**Report: DEFICIENCY REPORT
Function: Test, Adjust, & Balance
Date: 11/14/2022**

**PROJECT
11-14 CHICK-FIL-A #02053 - WAYCROSS, GA
(WAYCROSS FSU) REINVEST**

Issue Name : Hood 2 Side Bracket Not Installed

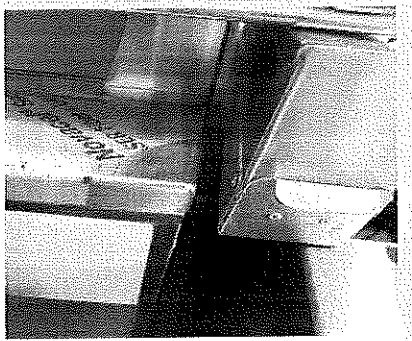
Description : The side bracket is not installed on hood 2.

Issue Name : Hoods 2 & 3 Not Secured At Pre Punched Locations

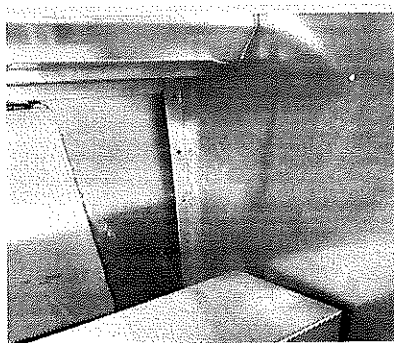
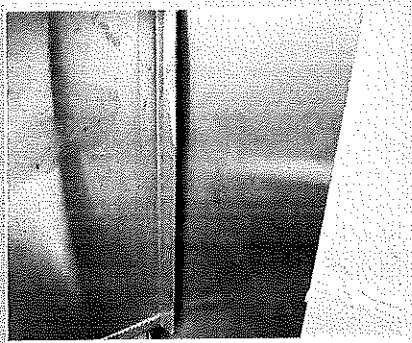
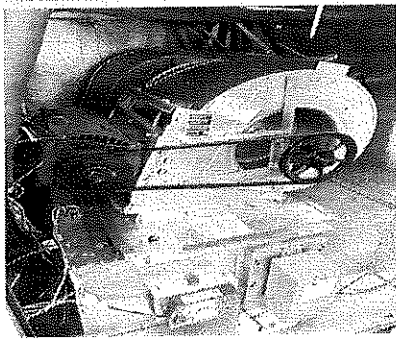
Description : Hood 2 does not have screws installed in all pre punched holes on the hood, due to this it is not sitting flush with the wall. Hood 3 does not have any pre punched holes, however, it is also not flush with the wall. Installing screws may close the gap. Any gaps left unresolved will collect grease over time.

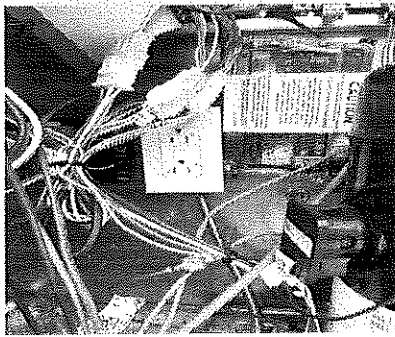
Issue Name : New RTU #1 No Belt Tensioner
Description : There is no belt tensioner installed on RTU #1.
Created By : National TAB **Assigned To :** National TAB - Stephen Tassinaro
Status : Open
Originated Date : 11/14/2022 - Stephen Tassinaro - National TAB

Issue Name : New RTUs Missing Caulking

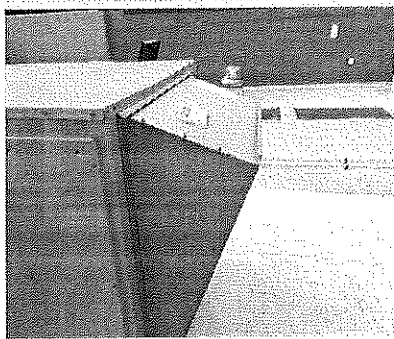
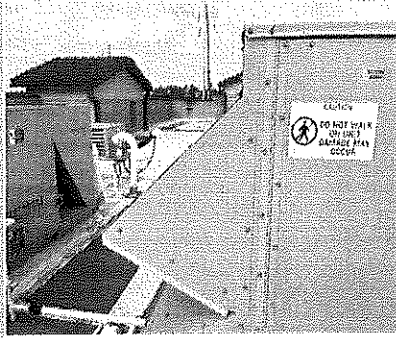
Description : New RTUs #1 and #5 do not have caulking installed at the corners of the OA hood.

Issue Name : Parts In Grease Trough

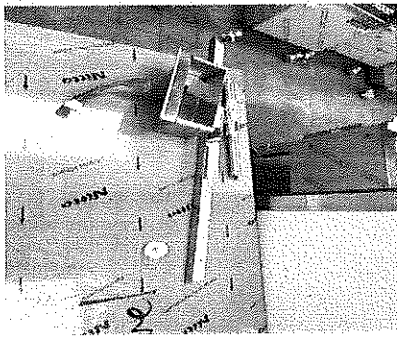
Description : See picture for the parts found in the Hood 1 grease trough.
